PLANNING COMMISSION MEETING

Project Name: 9101 Highland
 Description: Preliminary site plan approval recommendation & special land use approval
 Date on Agenda this packet pertains to: December 5, 2024

RE: 9101 Highland Road-Proposed Commercial Development- Preliminary Site Plan Review – 2nd Review

**Preliminary Site Plan / Special Land Use Review
for
White Lake Charter Township, Michigan**

TITLE:
FIRE TRUCK TURNING ANALYSIS

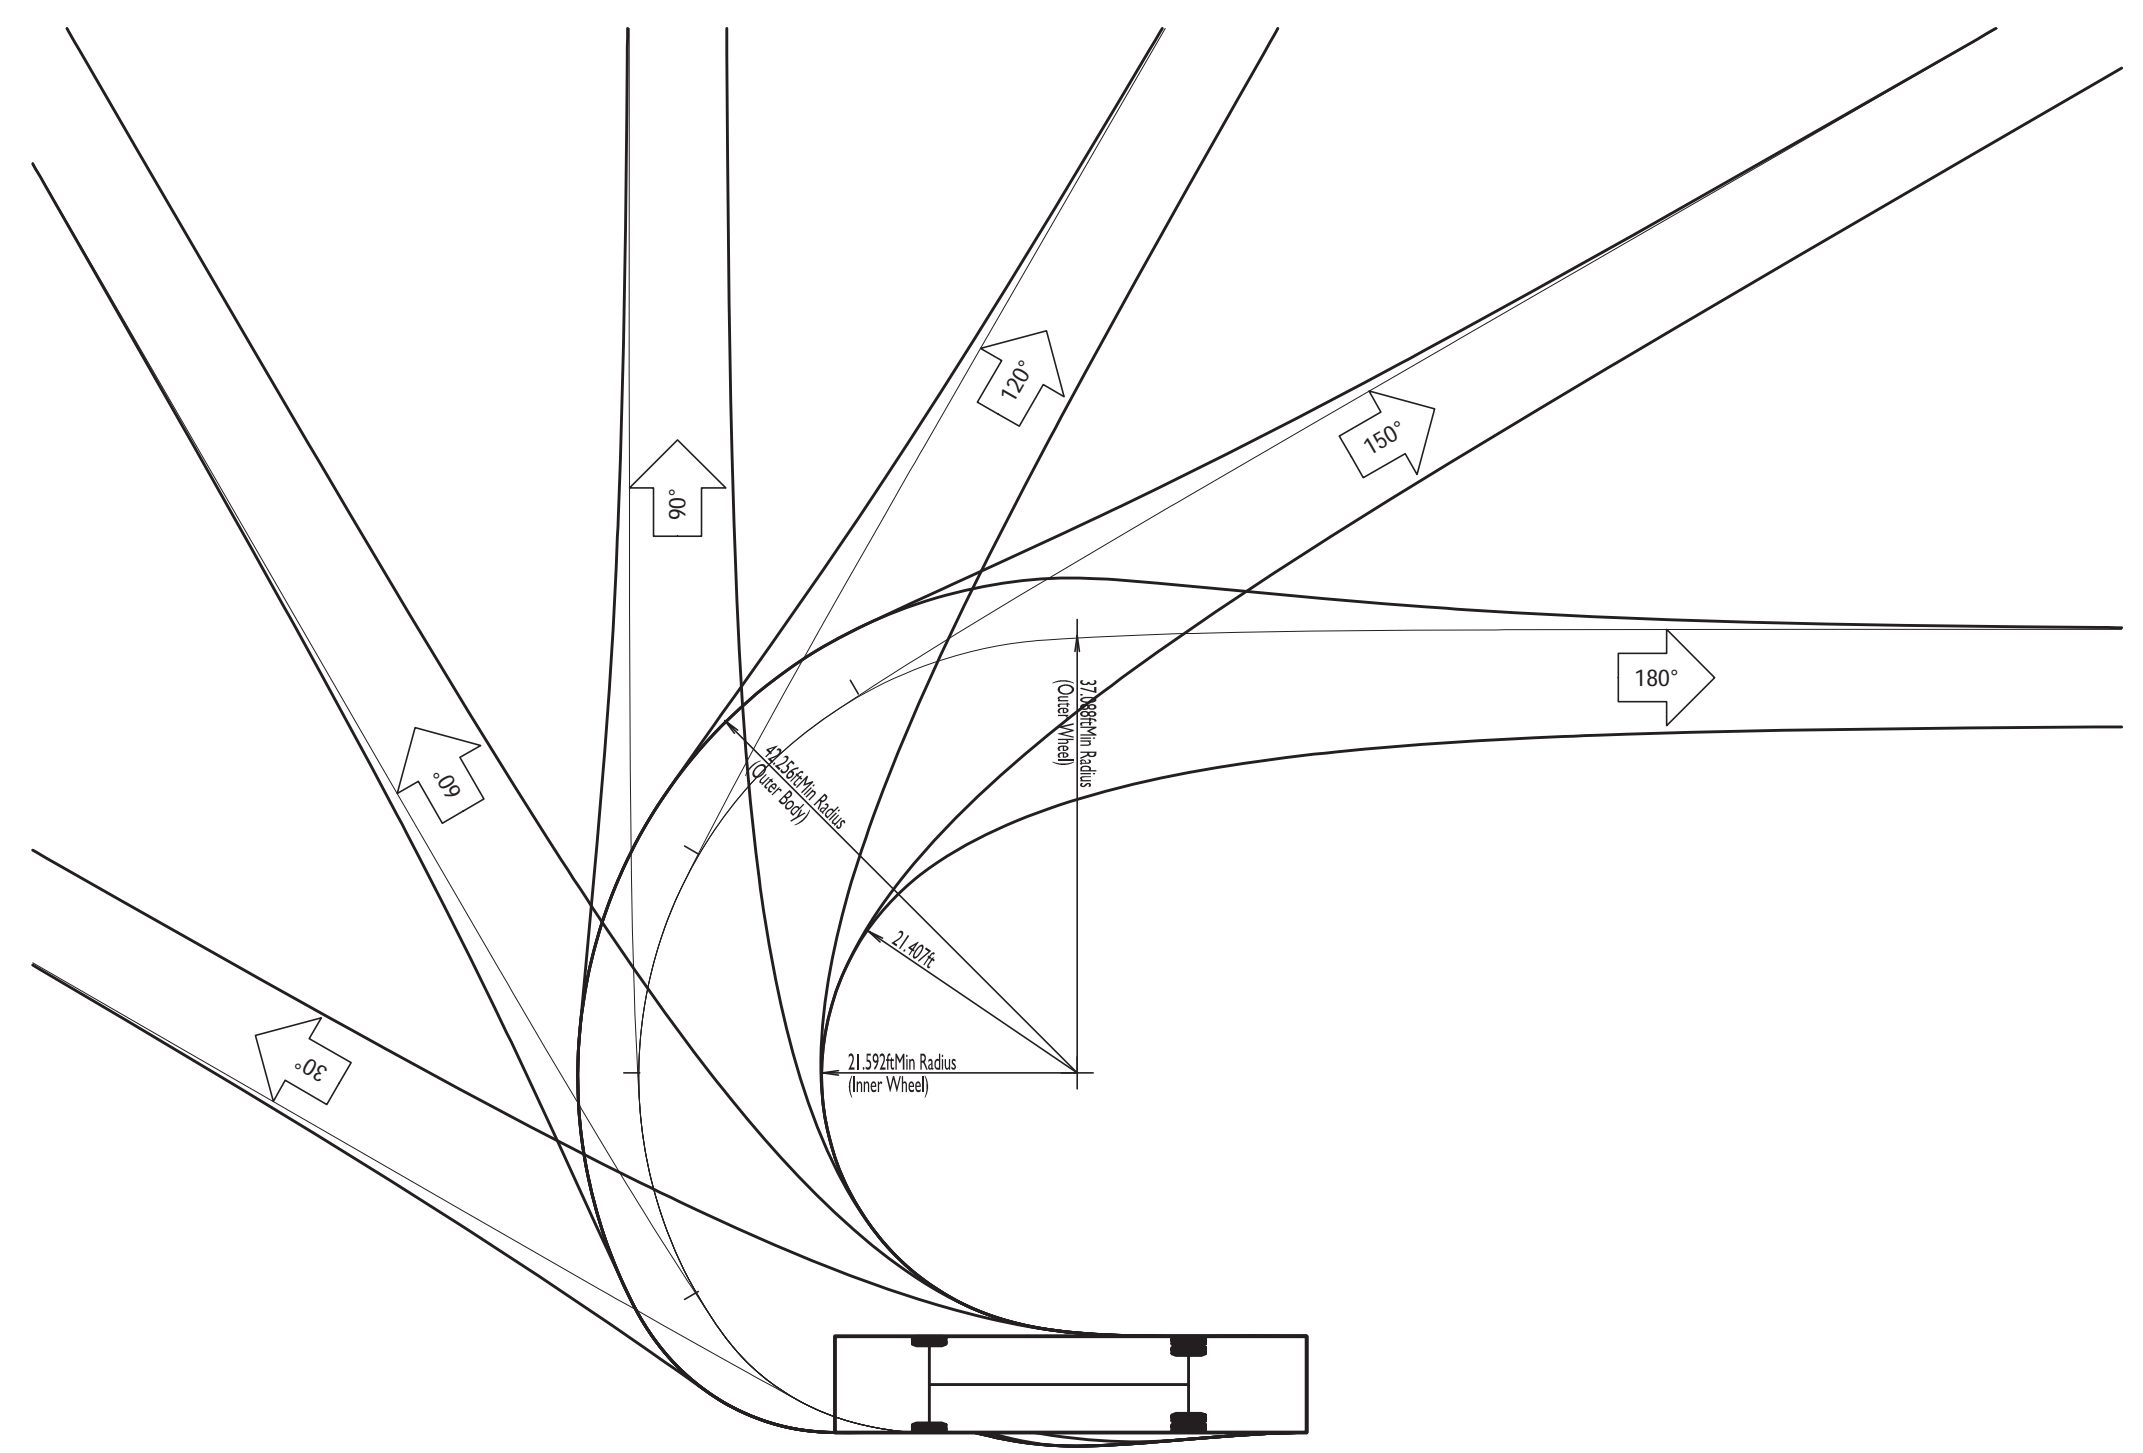
- d) *Provide plan indicating standard length fire truck access and turning radii so as to demonstrate adequate fire truck accessibility to and within the site. Comment addressed. Fire truck turning analysis has now been provided.*

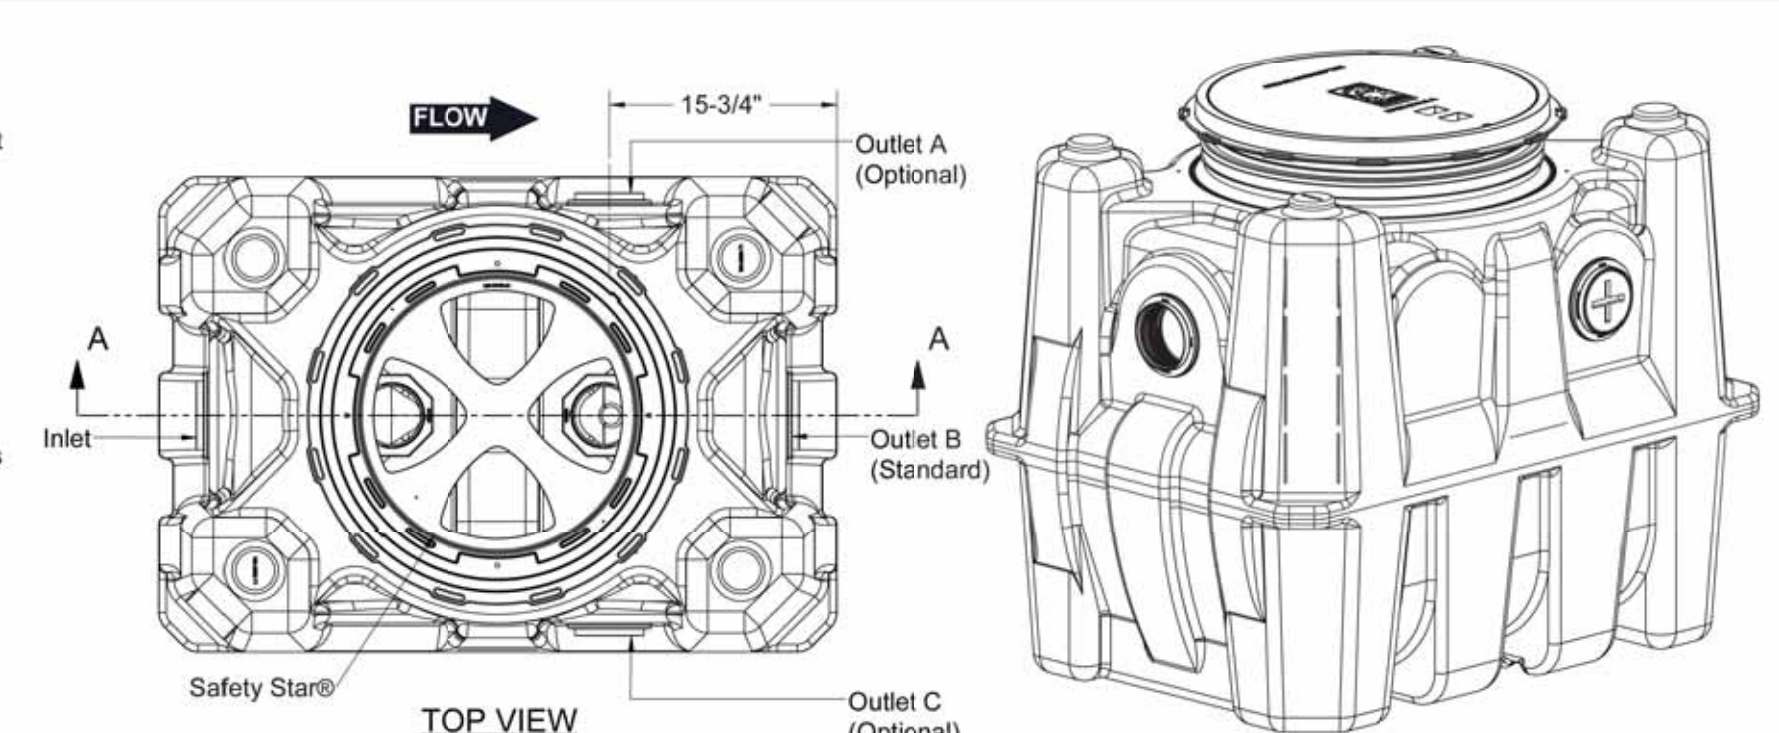
- v) *Sheet C-6- Specify size of the proposed grease interceptor for the westernmost building. A minimum capacity of 1000 gallons is required. **Comment outstanding. Although a detail for the GB-75 grease trap has now been provided on plan, it appears that the capacities (liquid-125 gal, grease-118 gal, and solids-31 gal) fall significantly short of the 1000 gallon minimum volume requirement.***

1 DUMPSTER GATE ELEV
 A-302 SCALE: 1/4" = 1'-0"

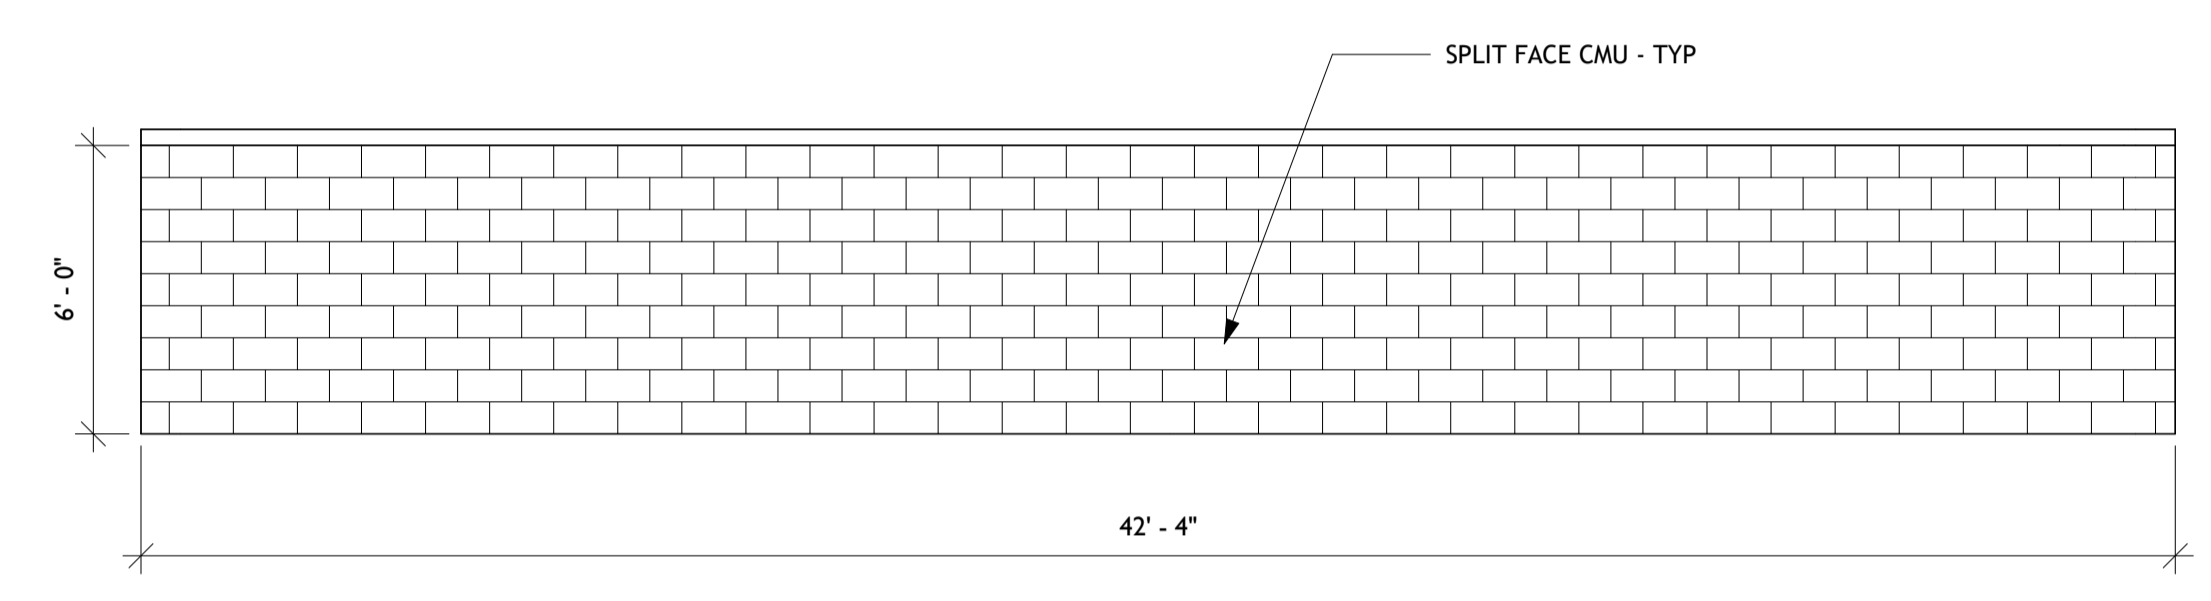
Trash enclosures are to be constructed of similar materials as the principal structure on the site. Brickform concrete or stained, decorative CMU block may be permitted where the principal building is not masonry, however, plain CMU block is not allowed. Details on Sheet C-13 indicate enclosure walls are constructed of split face block CMU but do not indicate a staining or decorative treatment. Sheet A-302 provides enclosure details that reference enclosure walls as CMU and gates materials as stained wooded with a metal frame. The applicant should remove the trash enclosure detail from Sheet C-13 and clarify the CMU enclosure wall decorative feature on Sheet A-302 for final site plan.

A-400

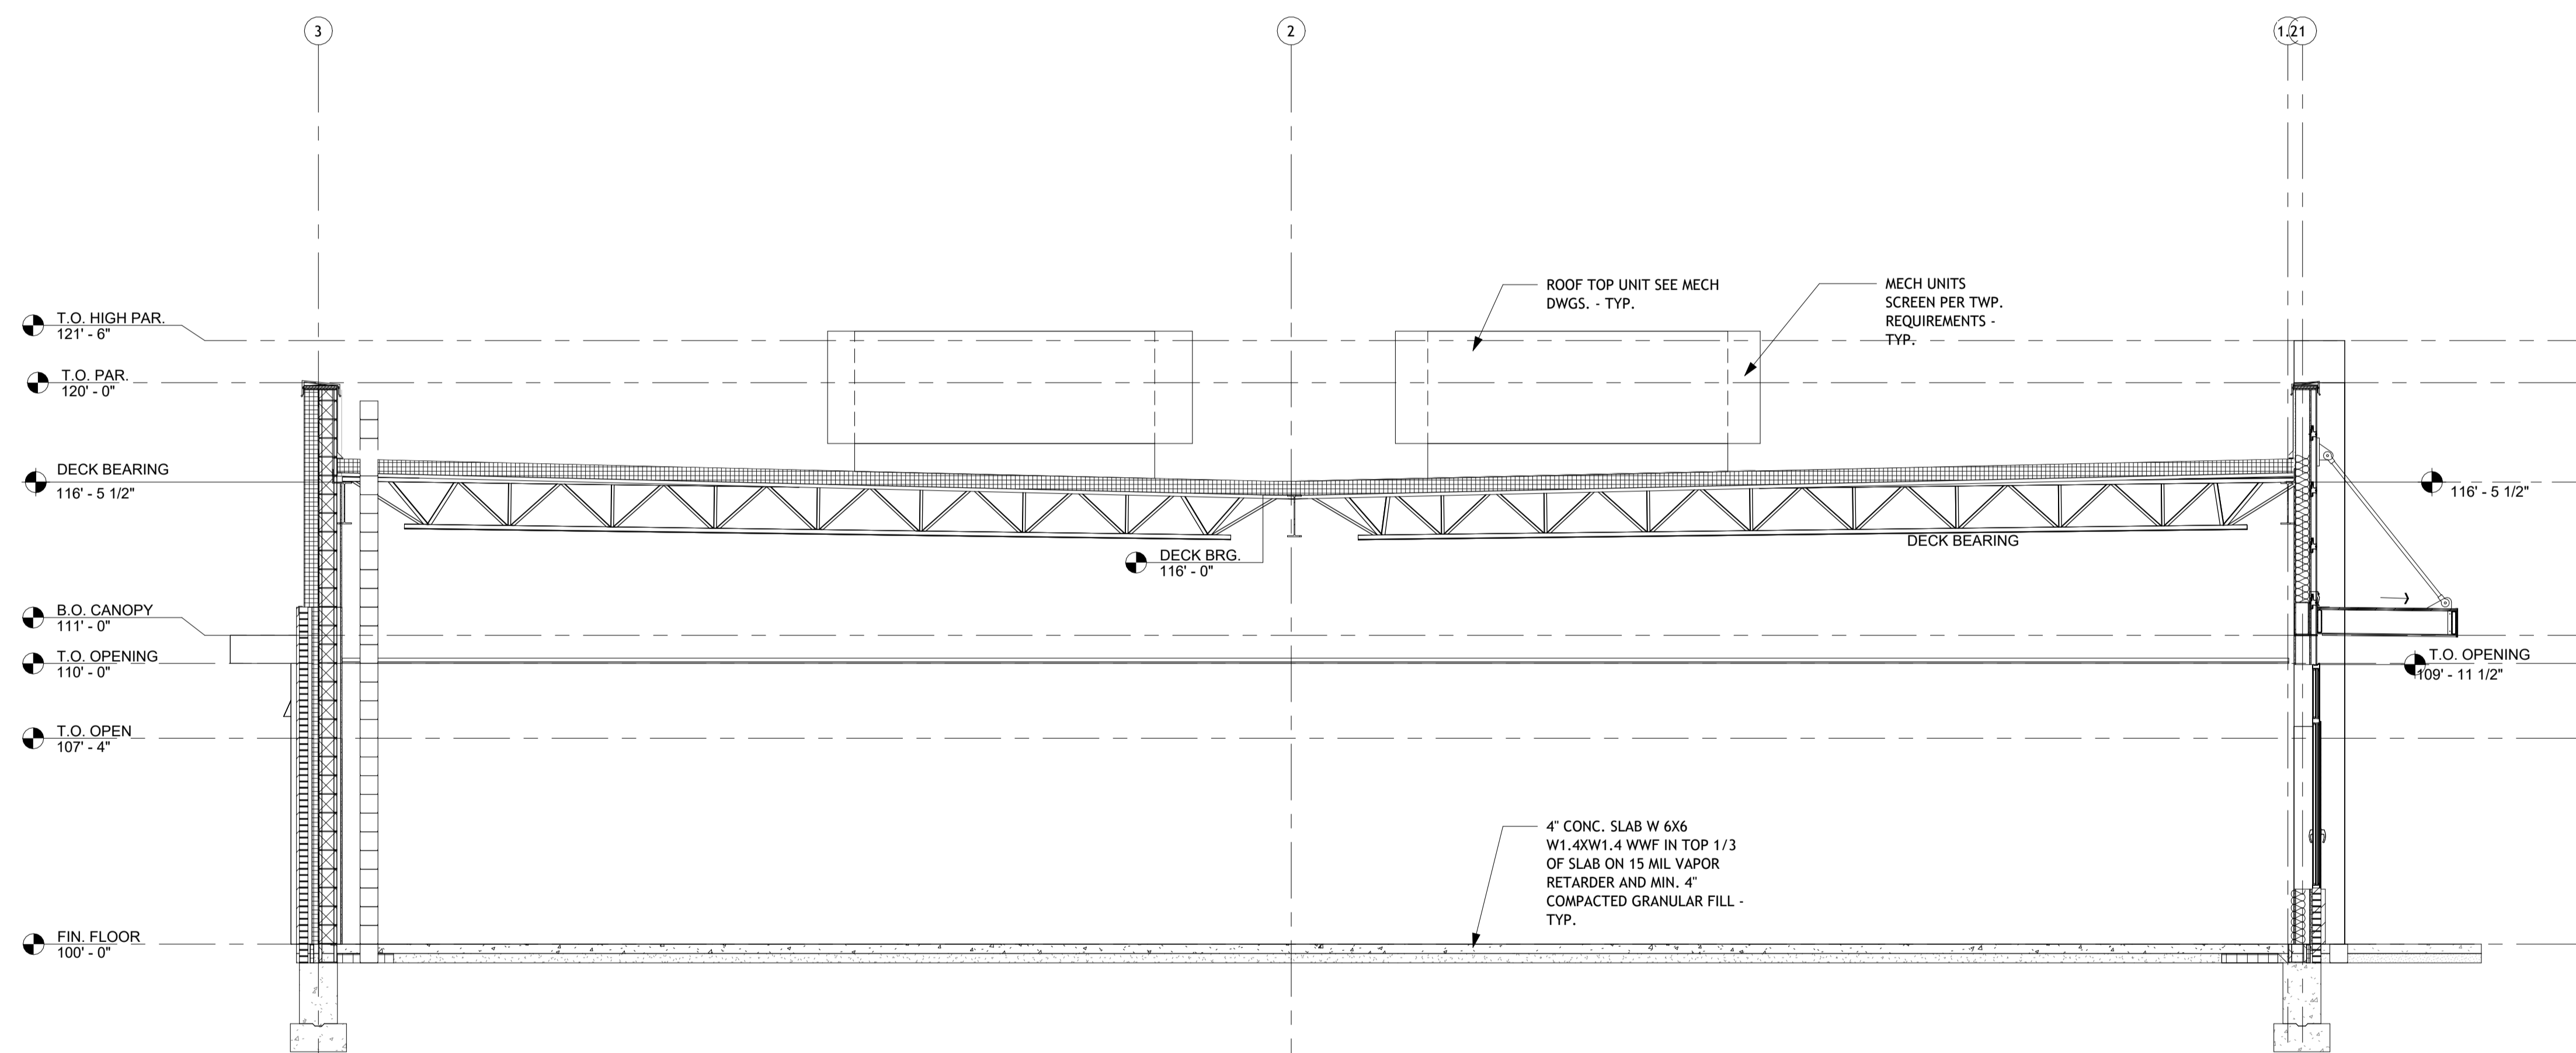
Sheet A-400 provides an elevation showing the rooftop mechanical equipment and the parapet dimensions which provide screening. Other onsite mechanical equipment is screened via landscaping.
